Technical Advisory

TA-2007_NSW1U-1

Intel® IP Network Server NSW1U

Figure 1

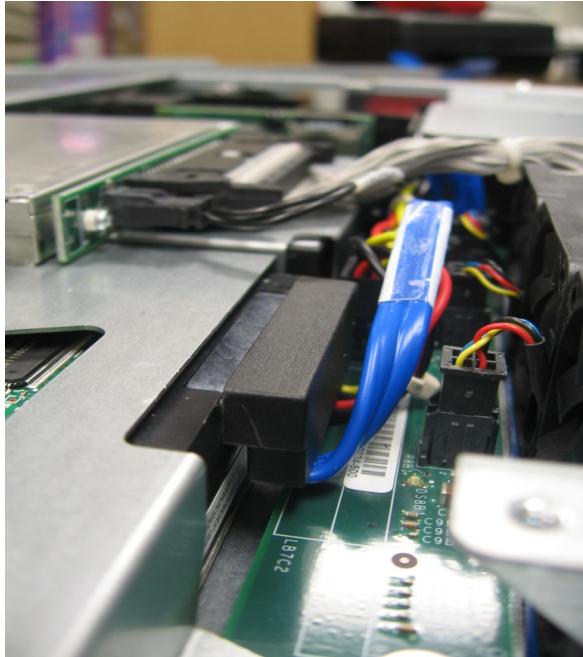
If a SATA drive signal cable is routed such that it touches the Ethernet Front Panel (EFP) board, rotational vibration from the fans may be transmitted to the hard drive through the SATA drive connector. This vibration can affect drive performance under some conditions.

When installing the SATA hard drives into the system, do not allow the SATA signal cables to touch the EFP board. The SATA cables exit the SATA drive connectors towards the Ethernet Front Panel (EFP) board and bottom of the chassis, as shown in Figure 1. Fold the cable upwards as it exits the SATA drive connector so it is sure to clear the EFP board.

Figure 1 and Figure 2 show how the longer SATA signal cable from the rightmost drive (bay 0) should arch over the SATA power cables in front of the fan power connectors.

Until a new fan bracket design is implemented, the immediate corrective action is to route SATA drive signal cables high enough so they do not touch the EFP board anywhere and transmit the fan vibration. Figures 1 -- 4 show how to route the signal cable (i.e., large blue cable with the label "SATA cable") by folding it so that it does not lie on the EFP board.

Figure 3

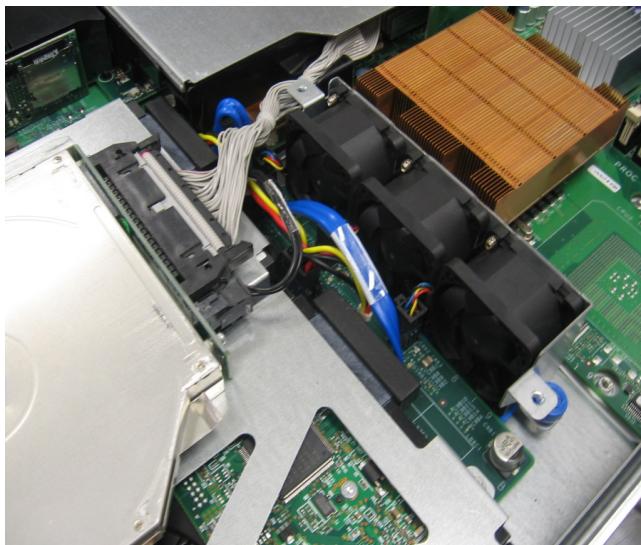
Figure 3 and Figure 4 show how the shorter SATA signal cable from the leftmost drive (bay 1) must be folded sharply on the other side of the optical drive IDE signal cable.
